Re: The Hub IV at Park and Speedway (Case No. T19SA00139) – Design Package Change Submittal

THE HUB IV AT PARK AND SPEEDWAY DESIGN PACKAGE CHANGE SUBMISSION

NOVEMBER 19TH 2019 - PROPOSED EXTERIOR DESIGN DEVELOPMENT ADJUSTMENTS

APPROVED TYNDALL AND SPEEDWAY RENDERING

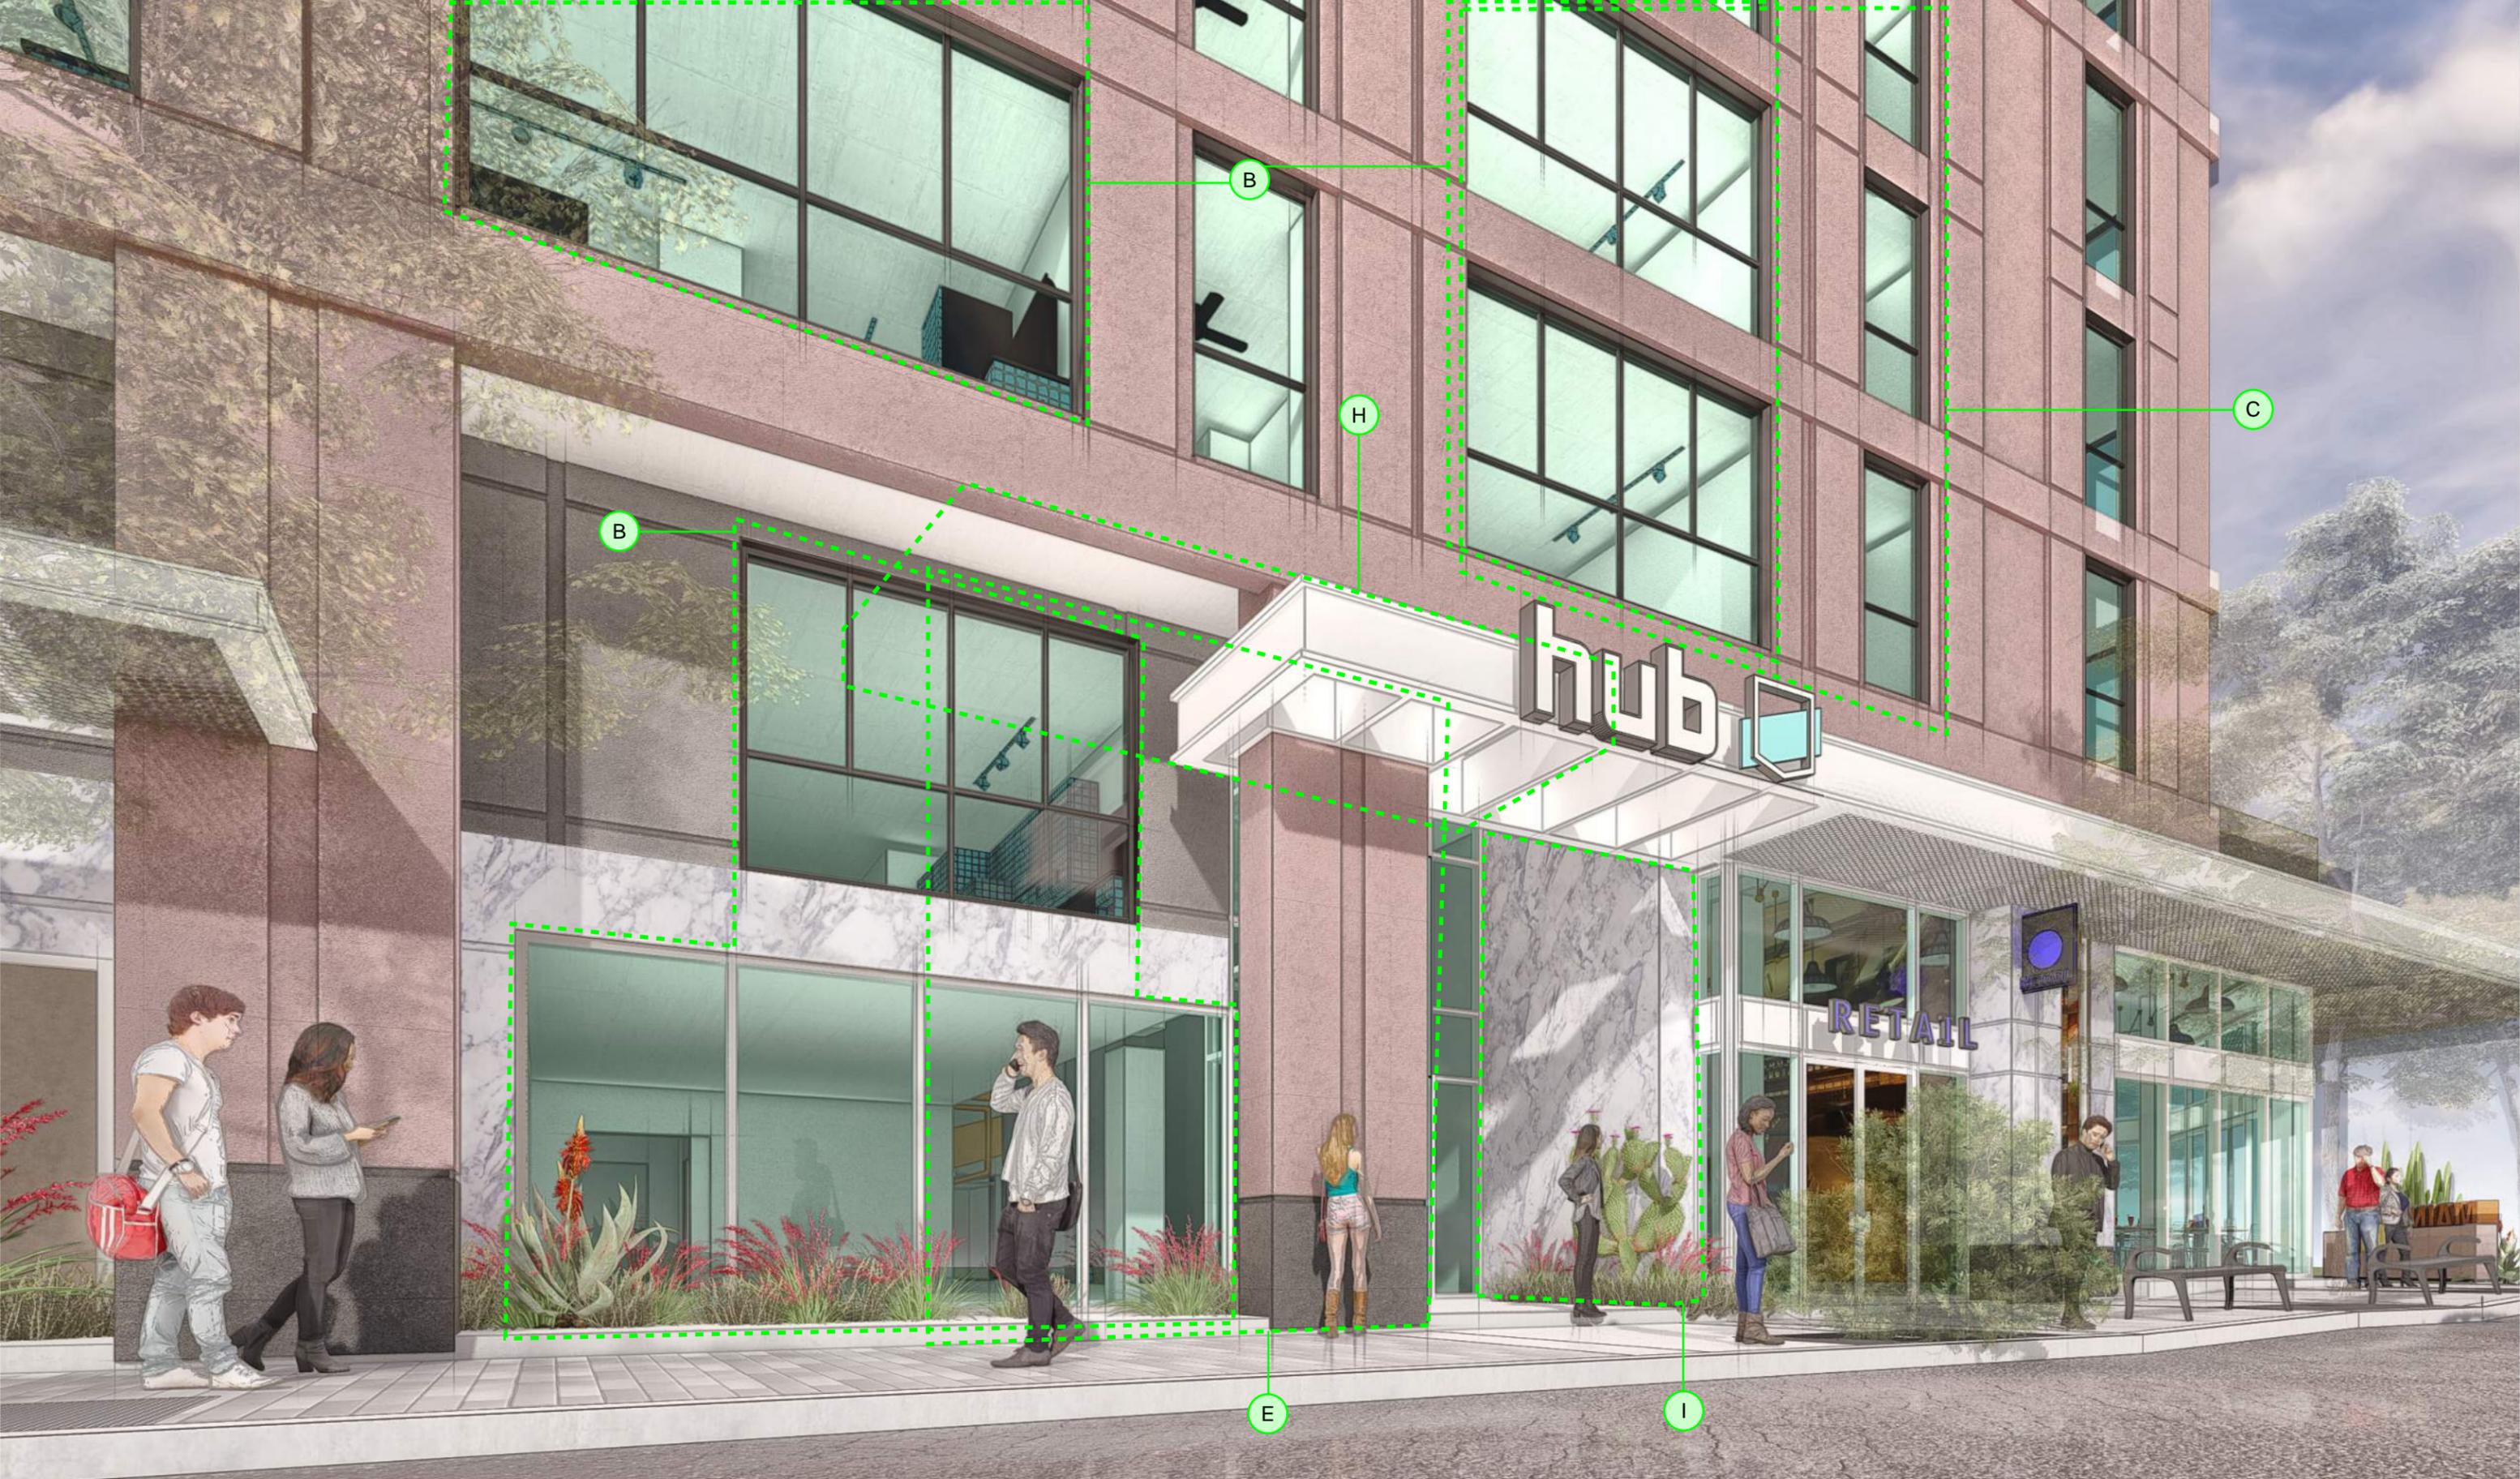
- A - Building height and parapet changes per zoning analysis and building height exhibit discussed with city staff
- B - Window size increase. Height of all windows increased by 6" and the window sill is 6" lower. Living room windows width increased to allow for more light and vent.
- C - Window relocated or added
- D - Door added or relocated for path of egress
- E - Column locations adjusted per structural evaluation
- F - Northeast duplex Town home removed and replaced with first level leasing office and mezzanine level unit
- G - Guardrail added for egress path fall protection
- H - Change to length of canopies due to column shift
- I - Rammed earth finish at entrance changed to porcelain tile with marble finish to be consistent with adjacent materials
- J - Wall shifted in response to transformer size increase
- K - Retail windows elongated to account for site slope.

PROPOSED TOWN HOMES ON PARK RENDERING

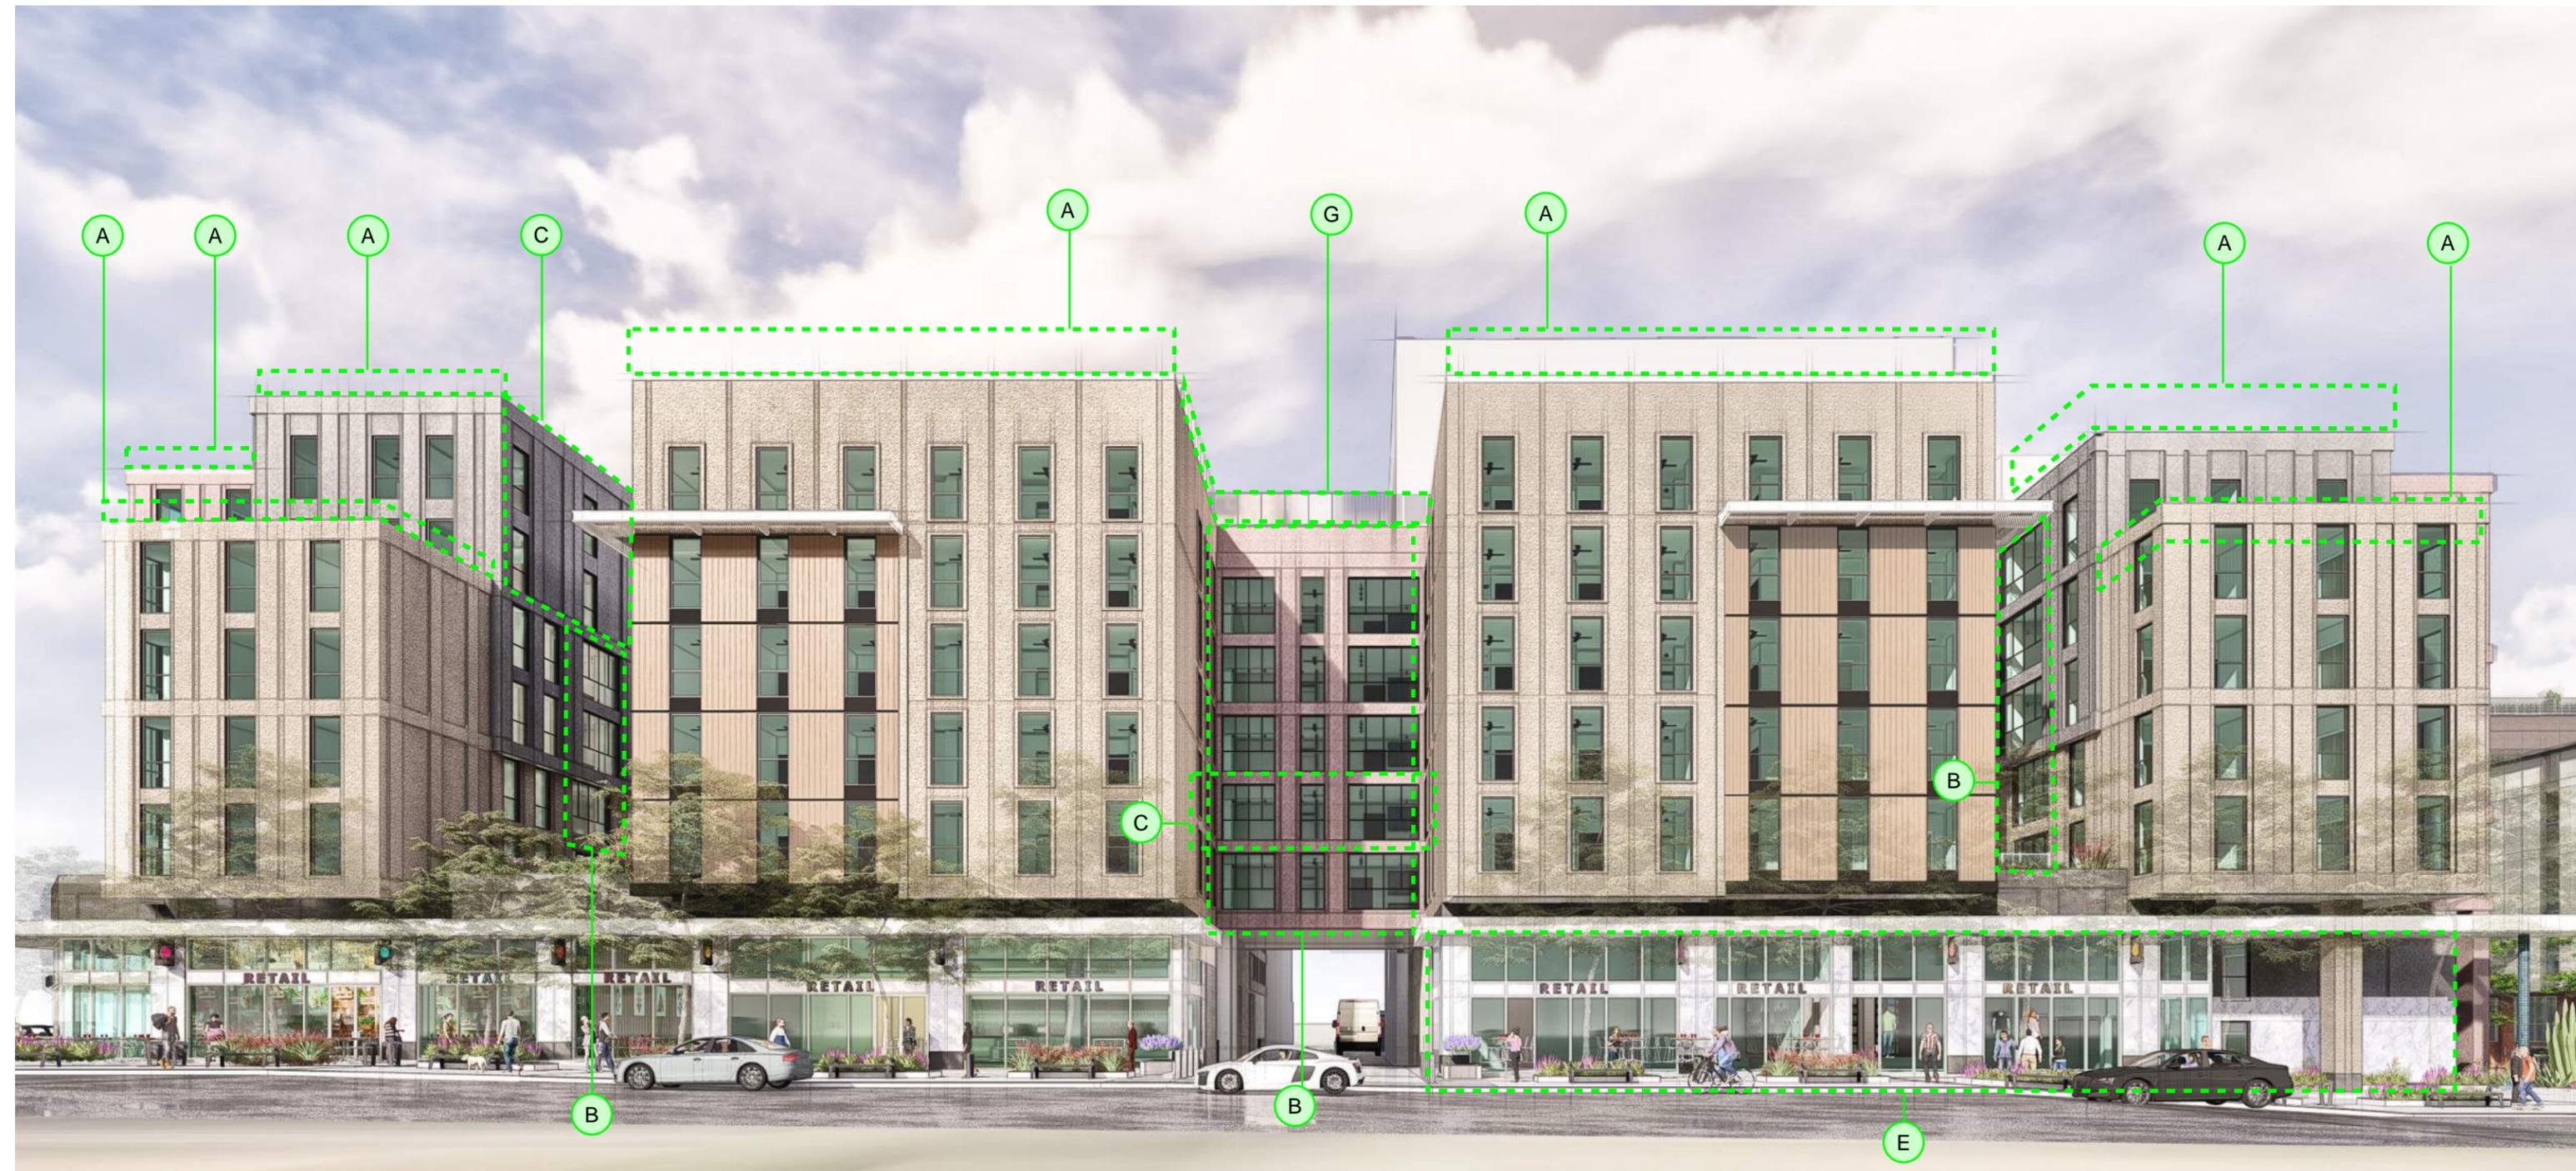
6. Ground floor Townhome Replaced by Leasing Office (Item F): One of the Park Ave. townhome units has been modified so the ground floor space is now a rental office, while the upper floor space remains a residential unit. This change has almost no impact on the Project's exterior design other than a minor adjustment of the exterior window location. This is a minor change as it has no effect on the Project's exterior design.
